## **Submission to the EPA Woodside Browse and North-west Shelf Proposals**

**12 February 2020**

Sustainable Energy Now Inc.

**Figure 3. International Energy Agency Sustainable Development Scenario for gas demand.**

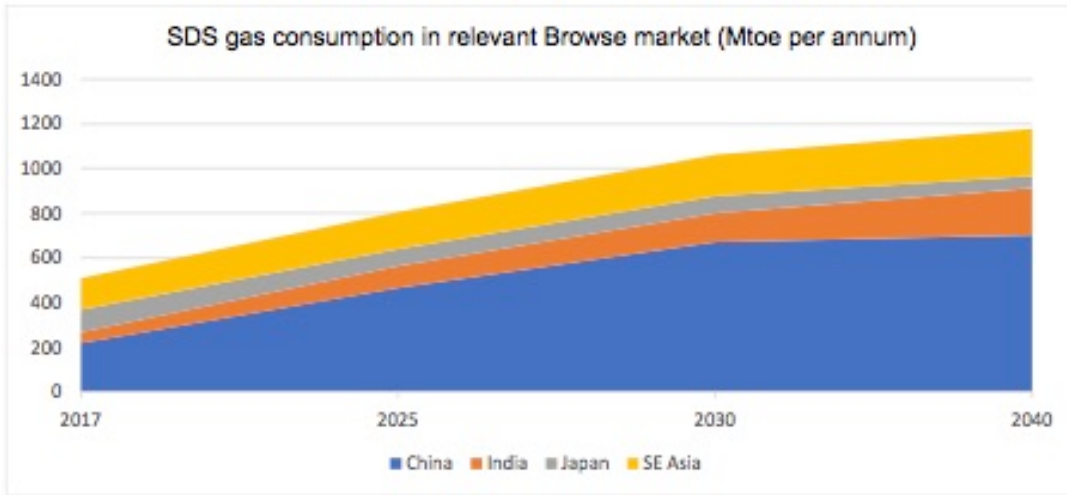
Woodside, on the other hand, is predicting an increase in gas demand until 2040:

A graphical representation is shown in Figure 3 (copied from [11, p. 690]).

The trajectories in Figure 4 are markedly different from those in Woodside’s proposals.

Climate Analytics went on to critique the SDS scenario used by Woodside (SEN's emphasis):

Thus, the gas demand scenario used by Woodside is problematic and contested. SEN wasn't able to access the IEA's full World Energy Outlook for 2019, but the abstract of the IEA's 2019 World Energy Outlook confirms that the SDS gas demand scenario used by Woodside is questionable.

Given this information, the EPA should carefully review the gas demand target models as it assesses the proposals.
